**COMPLIANCE REVIEW - ENGINEERING
PROPOSED MODIFICATION OF
PRELIMINARY & FINAL MAJOR SITE PLAN APPROVAL
APPLICANT : MAHALAXMI FLAGSHIP URBAN RENEWAL, LLC
PORTION OF BLOCK 751, LOT 1 & PORTION OF BLOCK 790, LOT 1
CITY OF BAYONNE, HUDSON COUNTY, NEW JERSEY**

April 11, 2021

MATRIX JOB NO. 13-454

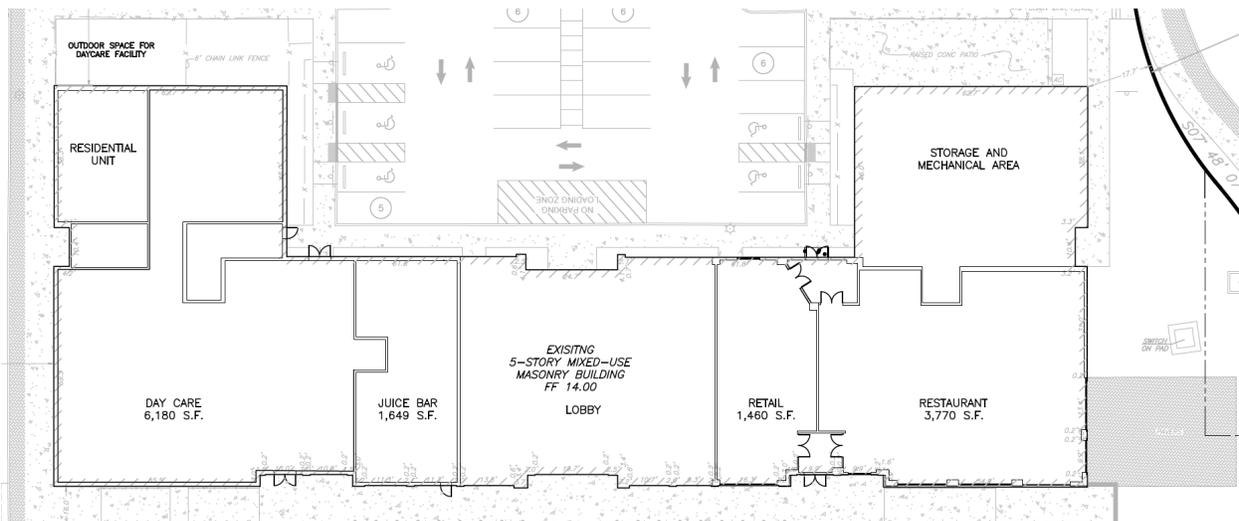
Matrix’s understanding of the proposed changes to the ground floor are as follows. Note, however, that these interpretations are based upon the limited ground floor layout information shown on the submitted Site Plan (see image below).

The net effect of this proposed ground floor layout, compared to the previously approved ground floor, is as follows:

- Reduction in number of residential units from nine to one (remaining unit at the northwest corner of the building remains unchanged). Total unit count for entire building is reportedly the same (97) with overall decrease in unit size.

- Increase in size of building devoted to non-residential use (retail/restaurant/day care) increased from to 5,907 sf to 13,059 s.f.
- Reduction in storage / mechanical area.
